## FIELD INSPECTION

| <b>Project Name:</b>  | Mountain Valley Pipeline | <b>Inspector:</b>              | Matthew Grant |
| <b>Spread: Montgomery County MP 230-231 St12235-12193 AR-276.03</b> | Spread H                 | <b>Weather (Wet/Dry/Rain):</b> | Dry           |

Fig. 3. St12210+00 SSF requires tree removal / maintenance

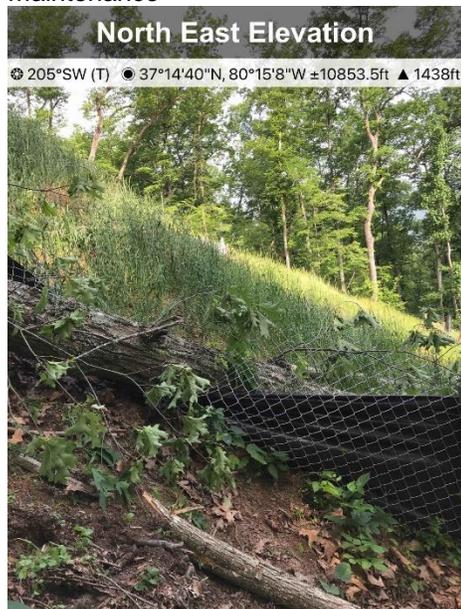
- Inspected designated streams included: S-C21
- ECD's were in place near the stream, no impacts were observed at the time of the inspection.
- St#12210+00 SSF requires maintenance

**Recommended Corrective Action:** Maintain all controls per the approved plan and specs.
